Local Concept Development Study for Monmouth County Bridge S-32 on Rumson Road (CR520) over the Shrewsbury River Borough of Rumson and Borough of Sea Bright

COMMUNITY STAKEHOLDERS MEETING NO. 2 MEETING REPORT

DATE: Tuesday, June 26, 2012

NO BUILD REHABILATION : CONCEPT / A

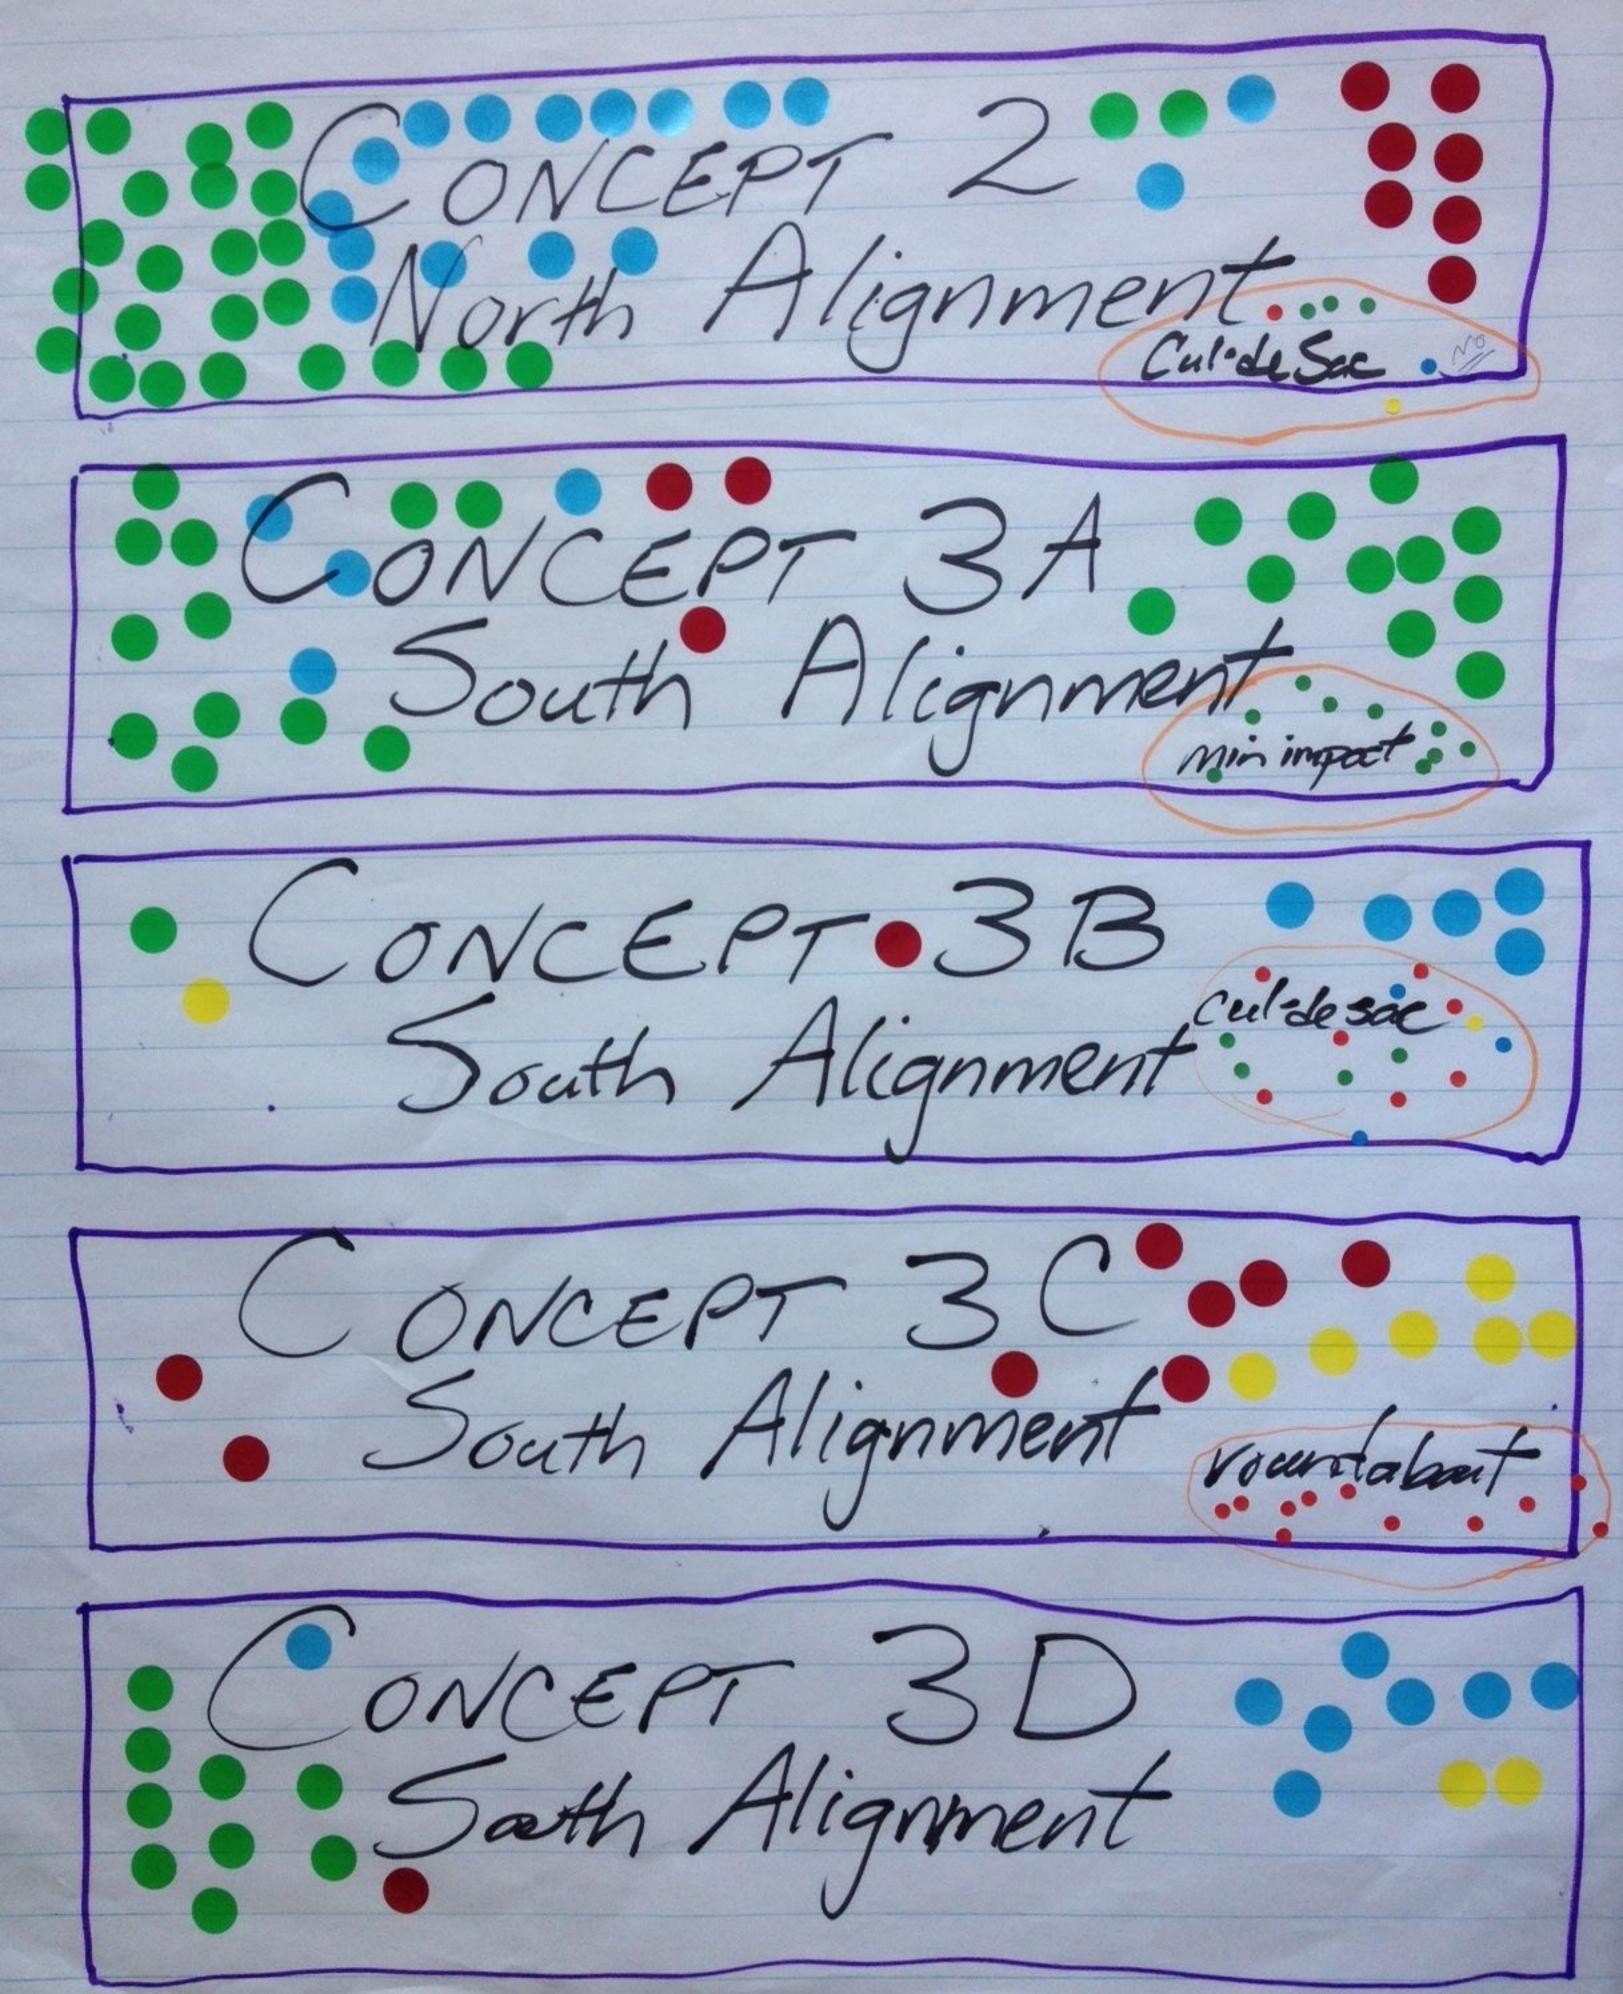
- c. Each table upon completion of the alternatives discussion, took turns placing their dots on the newsprint which listed each of the alternatives. (See Attachment No. 7 Alternatives List with dots on newsprint).
